Proposal for the 01 series of amendments to UN Regulation No. 35 (Foot controls)

Submitted by the experts from the Working Party on General Safety*

01 series of amendments to UN Regulation No. 35 (Foot controls)

Annex 1, item 5, amend to read:

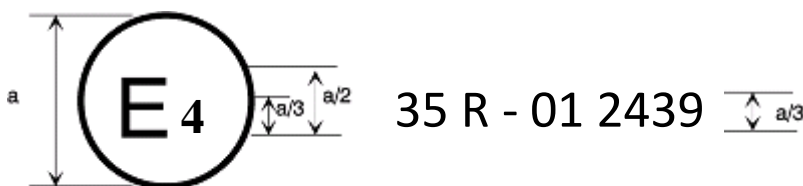
"5. Brief description of the vehicle type as regards the arrangement of foot controls and foot rest....."

Model B

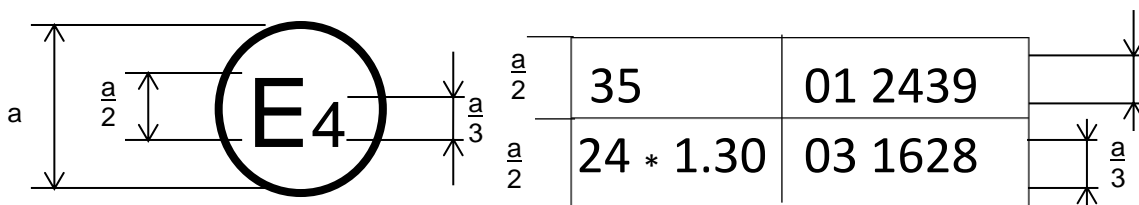
The above approval mark affixed to a vehicle shows that the vehicle type concerned has been approved in the Netherlands (E4) pursuant to UN Regulation Nos. 35 and 24.¹ (In the case of the latter UN Regulation the corrected absorption co-efficient is 1.30 m⁻¹). The first two digits of the approval numbers indicate that, at the date on which the respective approvals were granted, UN Regulation No. 35 included the 01 series of amendments and UN Regulation No. 24 included the 03 series of amendments.
